Product Change Notice

Issue Date: 1st July-2021

Introduction of replacement die for below part numbers.

Figure 1

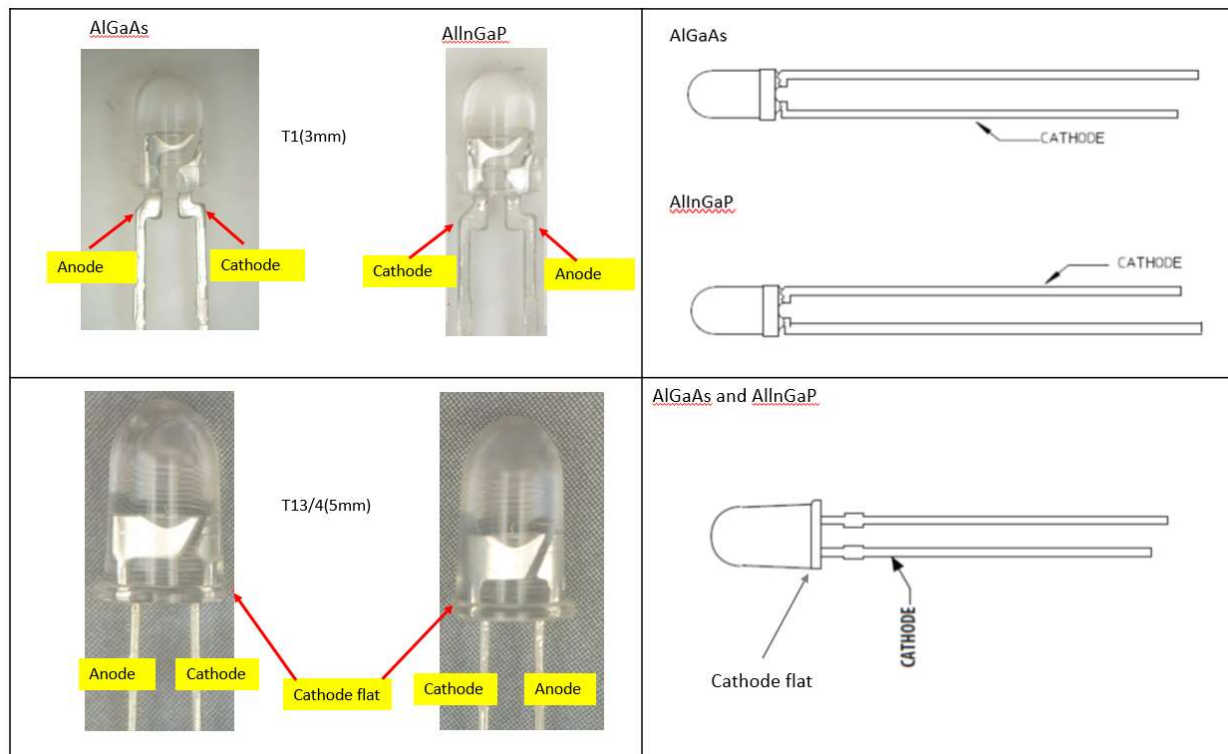
The new die (AlInGaP) will replace the existing dice (GaP and AlGaAs) for all affected part numbers.

Group 2 (AlGaAs LED Lamps) will have a change in form as shown in Figure 1.

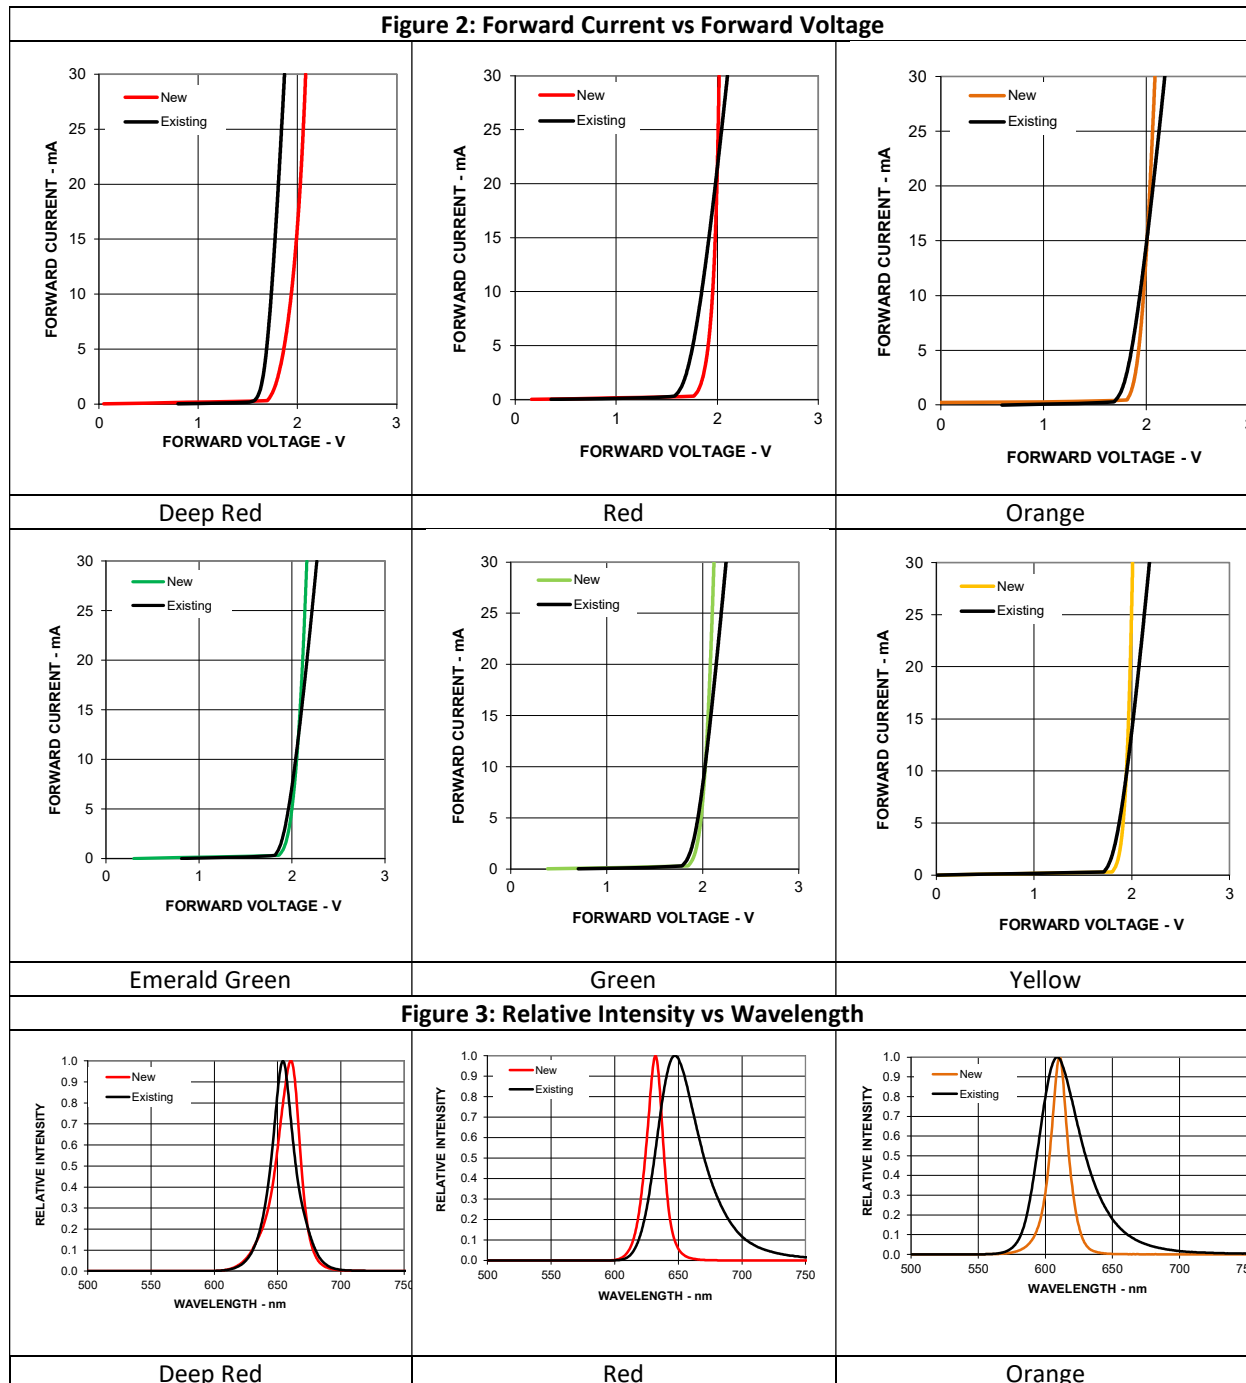
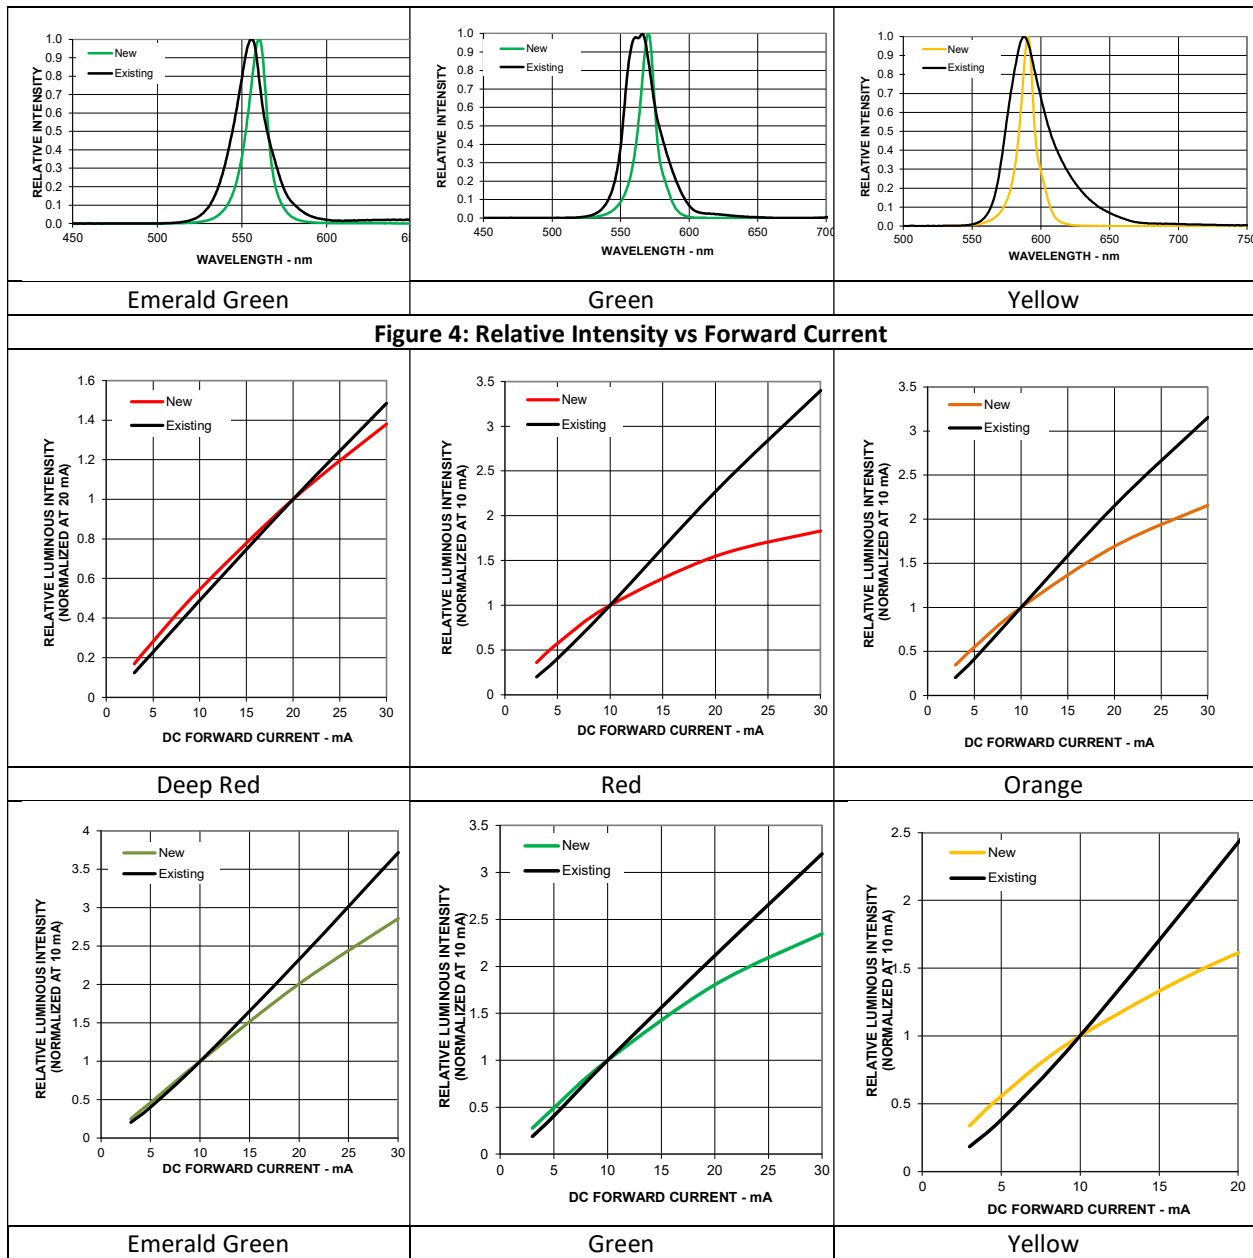
Following are the changes in product characteristic for both Group 1 and 2 of the LEDs.

1. Forward Current vs Forward Voltage.
2. Relative Intensity vs Wavelength
3. Relative Intensity vs Forward Current
4. Luminous Intensity : Some part numbers will experience higher typical intensity (refer to individual datasheet for details)
